Model: GR-C2_SOP	Date: 30-Jul-15	No.: RD196005
------------------	-----------------	---------------

Subject: Firmware Release Note: PowerSaving Sys		Prepared by: C. Shimaji	
From: 2nd Tech Service Sect., MFP/Printer Tech Service Dept.			
Classification:	<input type="checkbox"/> Troubleshooting <input type="checkbox"/> Mechanical <input type="checkbox"/> Paper path <input type="checkbox"/> Product Safety	<input type="checkbox"/> Part information <input type="checkbox"/> Electrical <input type="checkbox"/> Transmit/receive <input checked="" type="checkbox"/> Other (Firmware)	<input type="checkbox"/> Action required <input type="checkbox"/> Service manual revision <input type="checkbox"/> Retrofit information <input checked="" type="checkbox"/> Tier 2

This RTB has been issued to announce the firmware release information for the **PowerSaving Sys.**

Model: GR-C2b SPF	Date: 1-Oct-15	No.: RD196044a
-------------------	----------------	----------------

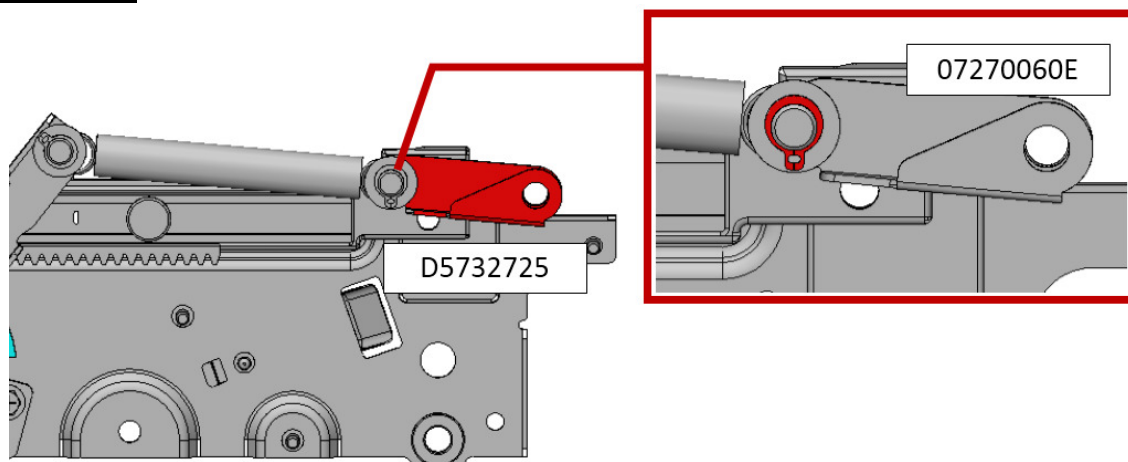
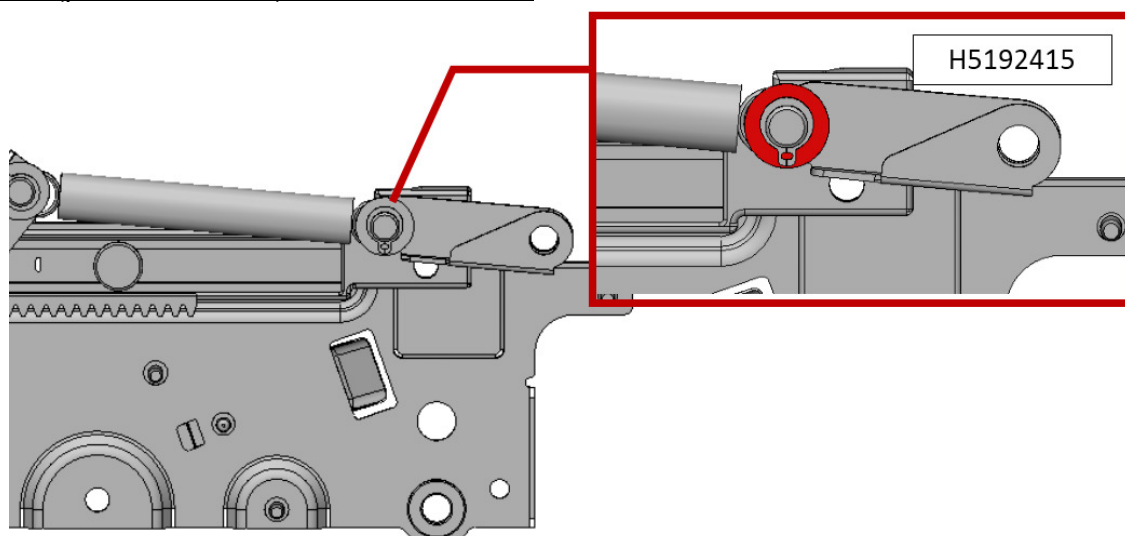
Reuse **WASHER:MM7.2** [6], by removing it from **LEVER:RISE:BASE:PEEN** [1] and reattaching it to the position shown below.

Washer (p/n: H5192415) attaches to here.

Top Page > Installation > Fax Unit Options > Handset Type C5502 (D645) (only for NA)  
 > Installation Procedure  
 Page: 17

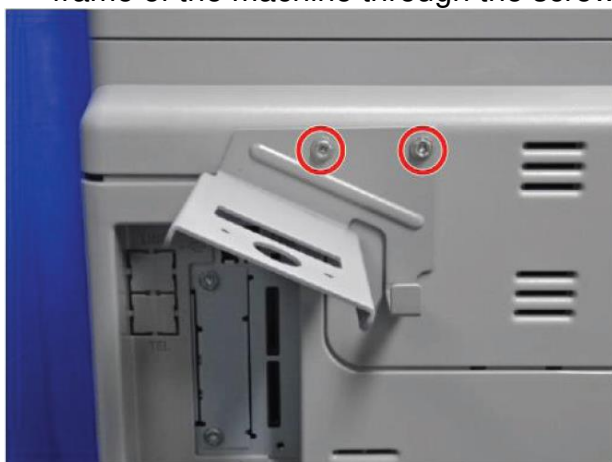
**Replace** the images for steps 4 and 5 as follows.

4. Attach the handset bracket to the upper left cover by securing two screws to the frame of the machine through the screw holes. (Screw (tapping) x 2)

5. Attach the cradle to the bracket. (Screw (flat head) x 2)

5. System Maintenance > Capturing the Debug Logs > Retrieving the Debug Logs >  
 Procedure for Retrieving the Debug Log via Web Image Monitor

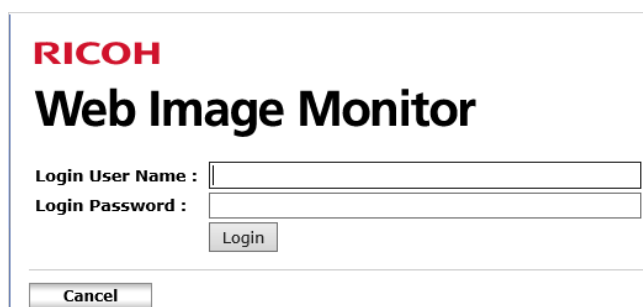
Add the debug log capturing procedure via Web Image Monitor. (This new function was added at Gr-C2 and later models.)

AZ240290

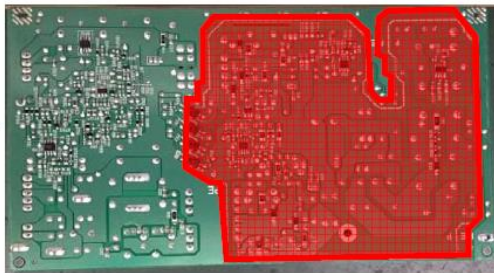
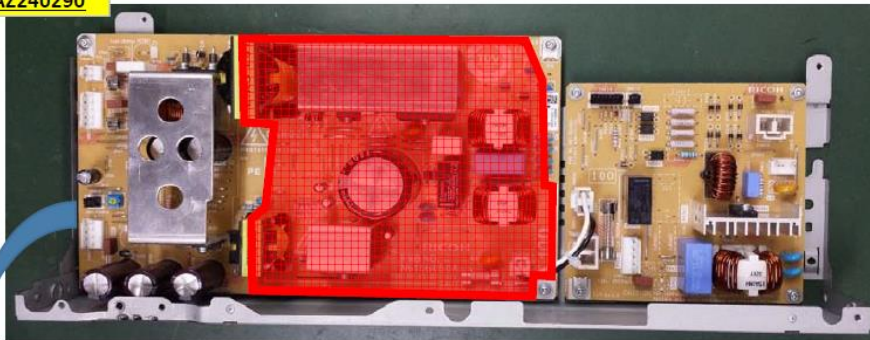
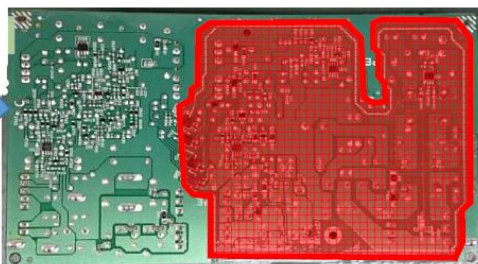
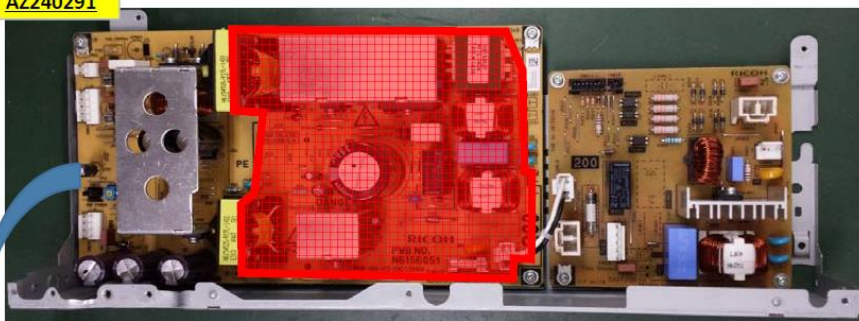
Residual charge of about 100V-400V remains in the AC circuits on the PSU board for several months even when the board has been removed from the machine after turning off the machine power and unplugging the power cord.

The procedure to discharge residual charge from the machine by unplugging the power cord from the AC wall outlet and pressing the main power switch works only for the DC circuits on this board. Residual charge remains in the AC circuits.

### a) 2. Installation > Anti-condensation Heater (for Mainframe Paper Tray) > Installation Procedure (P.123)

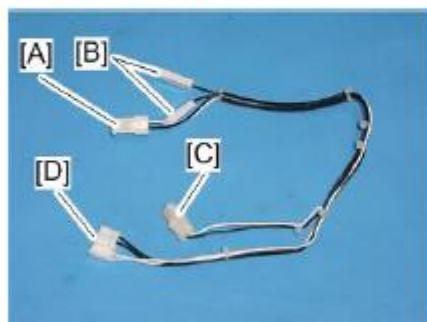
8. Connect the connector to CN600 on the PSU and route the junction harness along the red dotted line in the photo. (  × 1 )

d196z2022

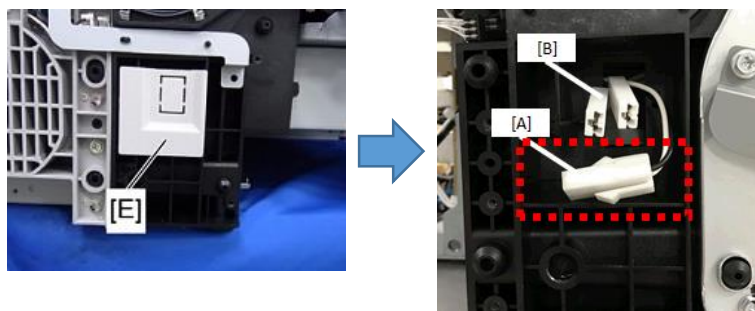
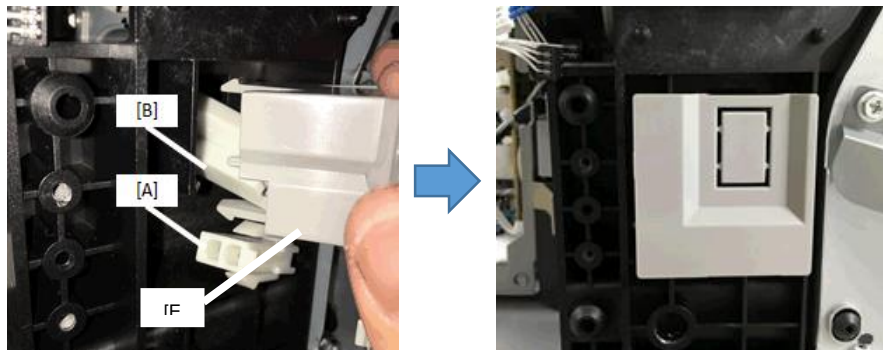
- If the anti-condensation heater for mainframe is not going to be installed, ~~put the connector [A] and the connector [B] into the area as shown below.~~ do the following:

- Remove the cover [E], and then pull out the junction harness connectors [A] and [B].
- Store the connector [A] in the open space shown below.

- Store the connector [B] into the cover [E], and then attach the cover [E].
